SPB Number: 2023.0305

INTERIOR LAYOUT & MILLWORK UPDATES

Issued: 10/04/2023

STANDARD PLAN BULLETIN NOTICE
RaceTrac Engineering and Construction Division

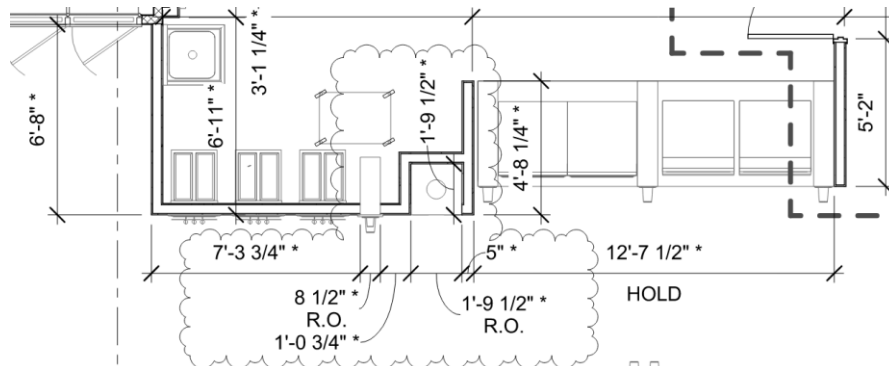
2. **SWIRL WORLD UPDATES:** Removed Fresh Blender #3032. Updated the layout to include Trash Can Millwork #0219 and adjusted the Yogurt Machines #4025 spacing.

- Sheets: A110, A120, A130, A140, A141, A150, A152, A501, A502, P120, P410, E100, E110, E150 & E431
- Attachments: A120

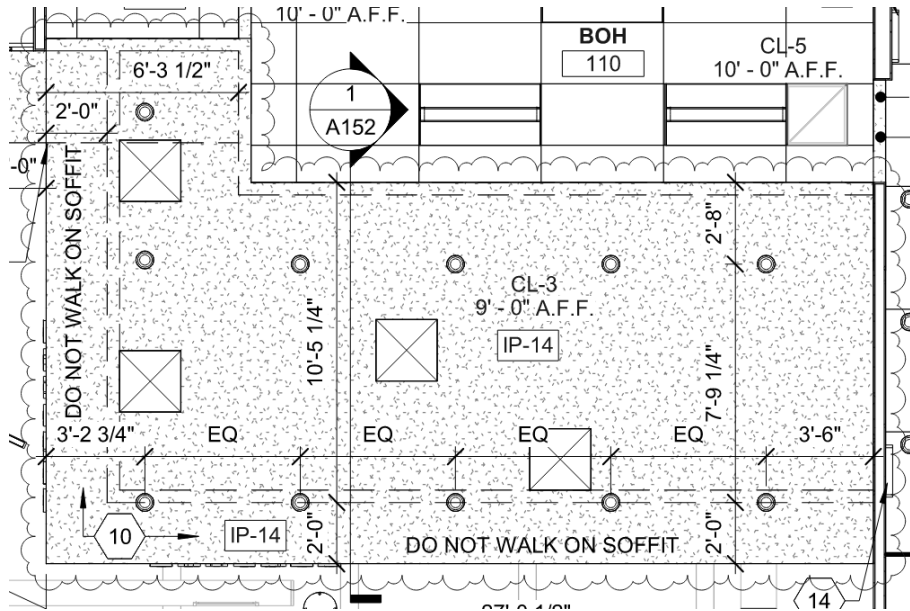
3. **SOFFIT @ GRAB & GO:** Updated the wall above soffit at Grab & Go. Removed hard/spiral duct work and adjusted the diffusers' locations and redesigned the duct work.

- Sheets: A150, A152, S201 & M120
- Attachments: A150

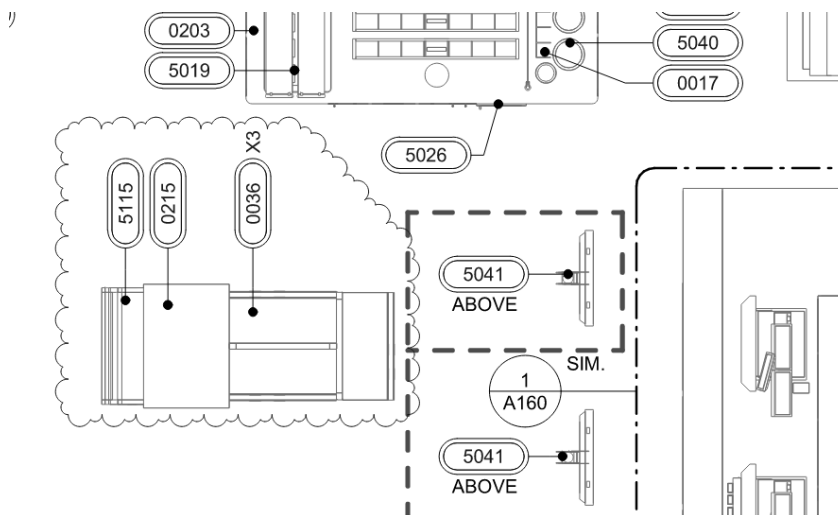
4. **EQUIPMENT LAYOUT UPDATE:** Replaced the 4-Way Ambient Cooler #4191 with (3) Gondolas #0036, Impulse Cooler #5115, and Display Case Millwork #0215.

- Sheets: A140, A141, E002, E100, E110 & E431
- Attachments: A140
